Access Compliance Report

Public Rights-of-Way

Intersection ID: 19670	Main Street: BROWN-GRIER_RD	Cross Street: WILDWOOD_MUSE_CT	Location: NW
ADA ID: 57B0B1A95E5C	Ramp Type: BlendTrans2	Initial Pass/Fail: Fail	Overall Compliance: No
Severity Score: 12.5			
Codes/Mitigation Info/Possible Solution		Field Measurements/Component Compliance

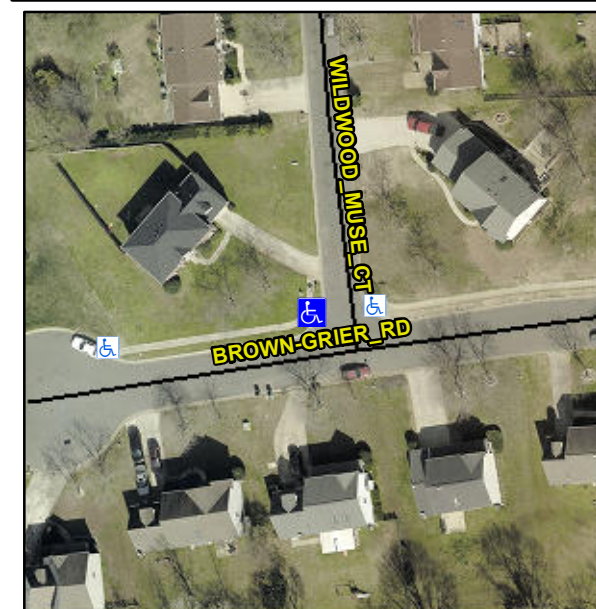
R304.5.3

Compliance	Description	Data	Compliance	Description	Data
N/A	Ramp Length (in)	97.0	Yes	BlendTrans Slope (%)	3.5
Yes	Ramp Width (in)	53.0	No	BlendTrans XSlope (%)	5.5
N/A	Flare Type LT	N/A	N/A	Flare Type RT	N/A
N/A	Flare Slope LT (%)	N/A	N/A	Flare Slope RT (%)	N/A
N/A	Flare Traversable LT?	N/A	N/A	Flare Traversable RT?	N/A
N/A	Landing Length (in)	N/A	N/A	DWS Provided?	N/A
N/A	Landing Width (in)	N/A	N/A	DWS Contrast?	N/A
N/A	Landing Slope (%)	N/A	N/A	DWS Length (in)	N/A
N/A	Landing X Slope (%)	N/A	N/A	DWS Full Width?	N/A
N/A	Landing Curb? (Y/N)	N/A	N/A	DWS Offset (in)	N/A
N/A	Shared Landing?	N/A			
N/A	Gutter Ponding?	N/A	N/A	Gutter Slope (%)	N/A
N/A	Gutter Lip Ht (in)	N/A	N/A	Gutter X Slope (%)	N/A
N/A	Painted X Walk1?	No	N/A	Painted X Walk2?	No
	X Walk 1 Direction	To S		X Walk 2 Direction	To E
	X Walk 1 Width (in)	N/A		X Walk 2 Width (in)	N/A
	X Walk 1 Slope (%)	3.2		X Walk 2 Slope (%)	1.9
	X Walk 1 X Slope (%)	1.8		X Walk 2 X Slope (%)	3.1

Remove & Replace Curb Ramp With Two New Directional Ramps or Equivalent.
